**Melbourne Planning Scheme Amendment C384melb
Land Subject to Inundation and Special Building Overlays**

Panel Report

20 December 2022

Figure 7 Map of the urban renewal areas where the Good Design Guide applies

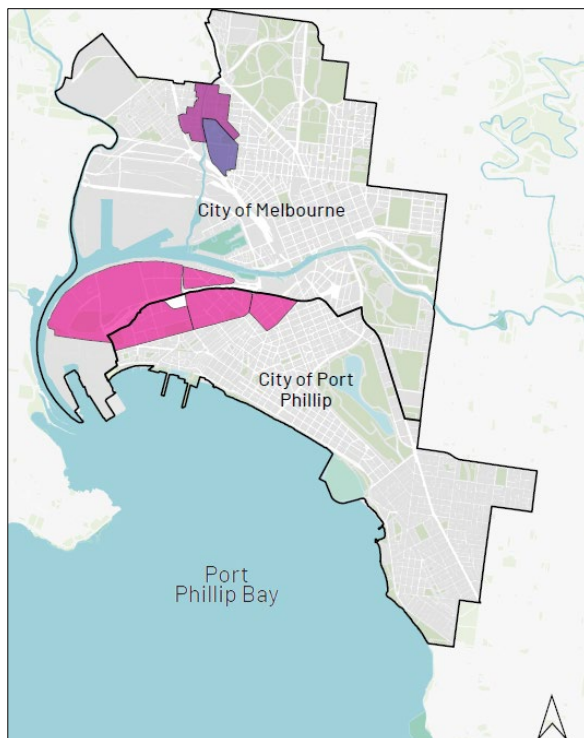
drafted to apply to the areas of Fishermans Bend, Arden and Macaulay (Figure 7). In the Amendment as exhibited, it is referenced in the Decision Guidelines of LSIO3, SBO2 and SBO3 which apply to a much greater area. To address the inconsistency, he said:

ESR agreed and submitted the Good Design Guide could expand its application to other areas such as Southbank, but should be updated so that it:

- is expressly applicable to areas other than Arden and Fishermans Bend (as it is currently expressed);
- provides a similar provision in relation to precinct works in the Southgate area as is included for Fishermans Bend so as to enable such works to reduce requirements for freeboard; and
- encompasses further consideration of the particular challenges faced when carrying out refurbishment of existing structures such as those located in renewal areas which have already been the subject of relatively intensive development (compare the relatively undeveloped state of Arden, Macaulay and Fishermans Bend with the relatively intensely developed state of Southbank).
